AUBURN HILLS 15TH ADDITION WICHITA, SEDGWICK COUNTY, KANSAS

RE: SUB 2003-122 -- One-Step Final Plat of Auburn Hills 15th Addition

STAFF REPORT
(One-Step Final Plat Approved 10/30/03)

CASE NUMBER: SUB 2003-122 -- AUBURN HILLS 15TH ADDITION

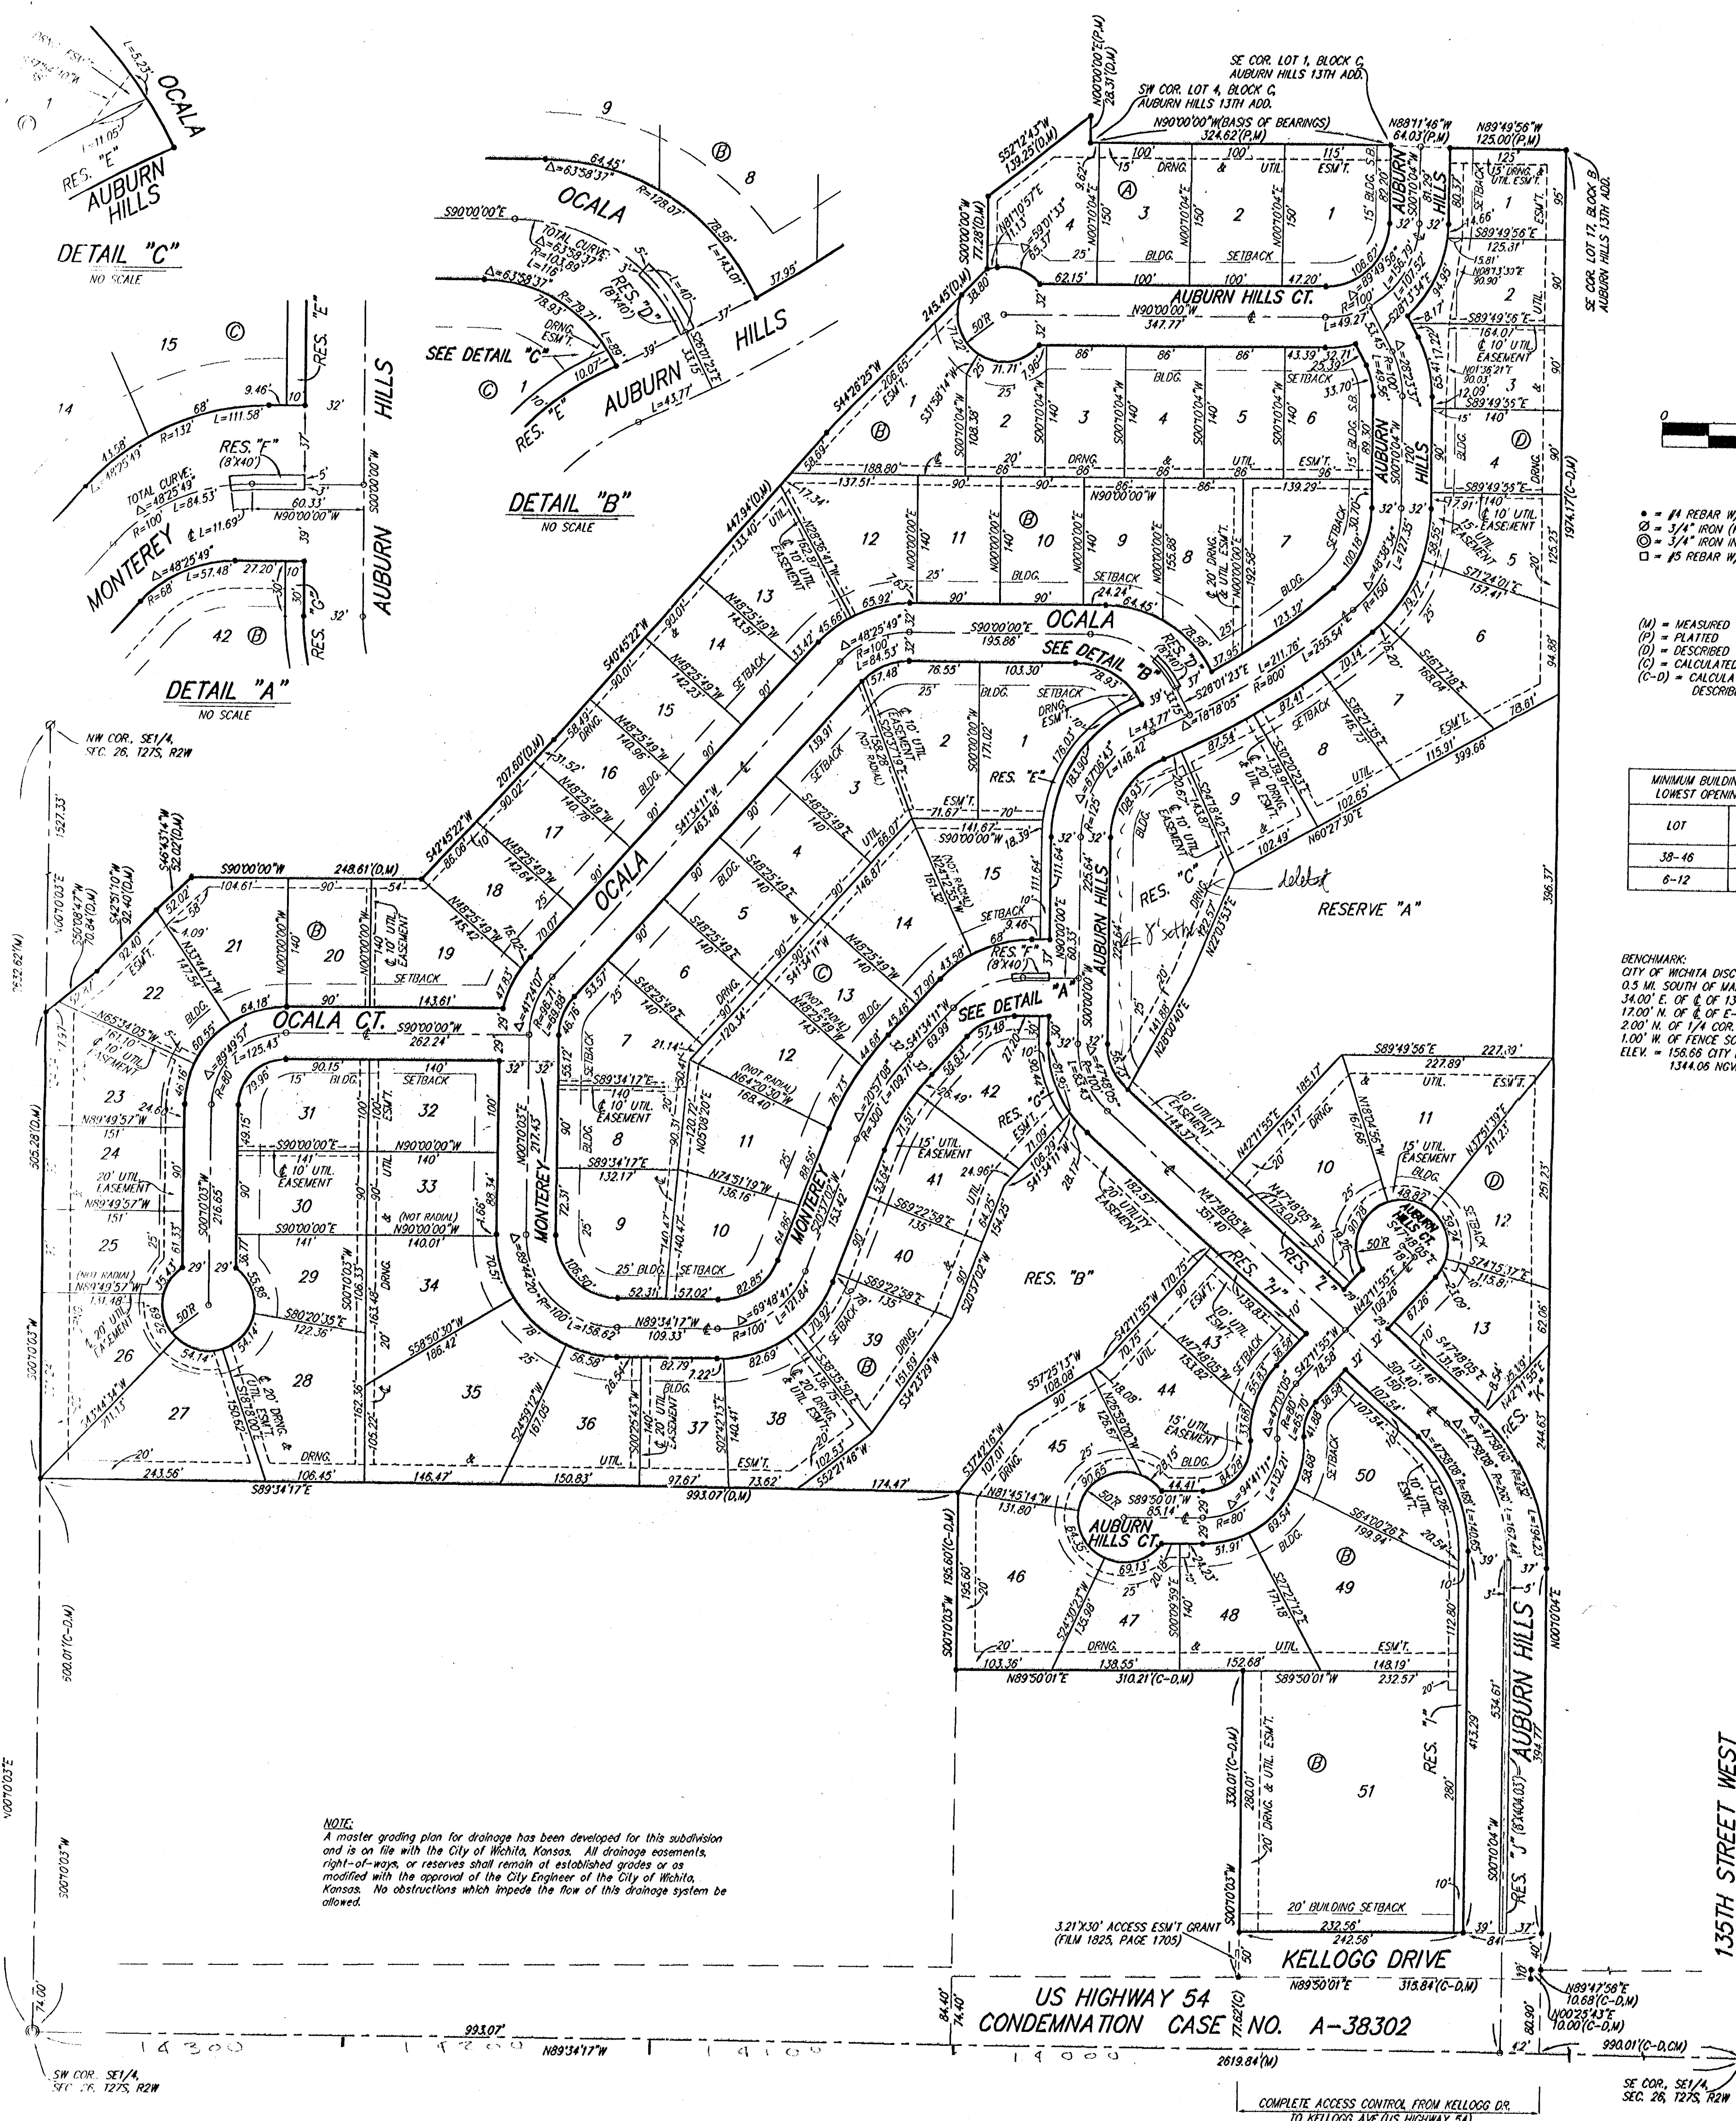
- D. City Engineering needs to comment on the status of the applicant's drainage plan. City Engineering requests additional information.
- E. The plat proposes a full movement intersection on Kellogg at a quarter-mile point on Kellogg. Traffic Engineering has advised that the City has worked with KDOT on an access management plan for the Kellogg Freeway that allows only signalized full movement intersections every half mile. The developer will need to obtain KDOT's approval for connection to Kellogg prior to development.

- F. The applicant is advised that the right-of-way width of Dogleg Cir may be revised to the 58-ft standard for cul-de-sac streets.
- G. The Applicant shall guarantee the paving of the proposed streets. The guarantee shall also provide for sidewalks on at least one side of all through, non cul-de-sac streets.

- H. As noted in the platlor's text, the applicant intends to restrict the utilities to easements on Reserves A and B and therefore such easements should be platted in these reserves.

- M. The blocks need to be renumbered (dividing Block A into two blocks) as the perimeter of the blocks should be bounded by streets. Block D should be encompassed within Block A.

- N. GIS needs to comment on the plat's street names. *The will be requesting that Dogleg in the adjacent plat to the north be revised to Auburn Hills by affidavit. The northernmost cul-de-sac shall be denoted as "Ct". Cross St. shall be assigned two new street names.*

- P. For any lots with existing tree rows that may be impacted by the installation of utilities, it is recommended that 30-ft utility easements be platted in order to allow for the installation of the utilities without damage to such tree rows.
